Access Compliance Report

Public Rights-of-Way

Intersection ID: 47909	Main Street: MOUNTAIN_QUAIL_DR	Cross Street: HARRIER_RD	Location: W
ADA ID: D986D9048946	Ramp Type: PerpDiag	Initial Pass/Fail: Fail	Overall Compliance: No
Severity Score: 31.25			
Codes/Mitigation Info/Possible Solution		Field Measurements/Component Compliance

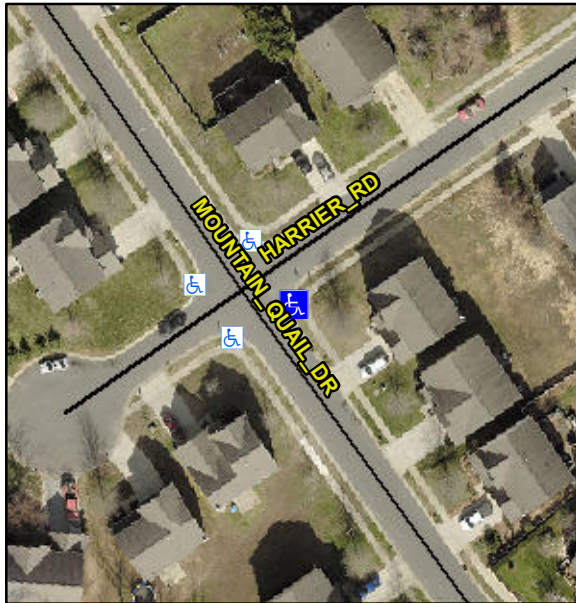
Not Found, R304.5.1, R304.2.2, R304.5.3

Compliance	Description	Data	Compliance	Description	Data
N/A	Ramp Length (in)	48.0	No	Ramp Slope (%)	11.9
No	Ramp Width (in)	35.0	No	Ramp XSlope (%)	2.6
N/A	Flare Type LT	N/A	N/A	Flare Type RT	N/A
N/A	Flare Slope LT (%)	N/A	N/A	Flare Slope RT (%)	N/A
N/A	Flare Traversable LT?	N/A	N/A	Flare Traversable RT?	N/A
N/A	Landing Length (in)	N/A	N/A	DWS Provided?	N/A
N/A	Landing Width (in)	N/A	N/A	DWS Contrast?	N/A
N/A	Landing Slope (%)	N/A	N/A	DWS Length (in)	N/A
N/A	Landing X Slope (%)	N/A	N/A	DWS Full Width?	N/A
N/A	Landing Curb? (Y/N)	N/A	N/A	DWS Offset (in)	N/A
N/A	Shared Landing?	N/A			
N/A	Gutter Ponding?	N/A	N/A	Gutter Slope (%)	N/A
N/A	Gutter Lip Ht (in)	N/A	N/A	Gutter X Slope (%)	N/A
N/A	Painted X Walk1?	No	N/A	Painted X Walk2?	No
	X Walk 1 Direction	To NE		X Walk 2 Direction	To SE
N/A	X Walk 1 Width (in)	N/A	N/A	X Walk 2 Width (in)	N/A
	X Walk 1 Slope (%)	2.6		X Walk 2 Slope (%)	0.6
	X Walk 1 X Slope (%)	4.2		X Walk 2 X Slope (%)	2.1

N/A	Ramp inside XWalk1?	N/A	N/A	Ramp inside XWalk2?	N/A
	Road Slope (%)	3.2	N/A	Clear Space?	N/A
	Road X Slope (%)	5.7	N/A	Clear Space to XWalk (in)	N/A
N/A	Any Obstructions?	N/A	N/A	Storm Grate/Utility Hazard?	N/A
	Obstruction Type			Storm Grate/Utility Type	
		N/A			N/A
			Yes	Surface Condition? (G/P)	Good

Remove & Replace Curb Ramp With Two New Directional Ramps or Equivalent.
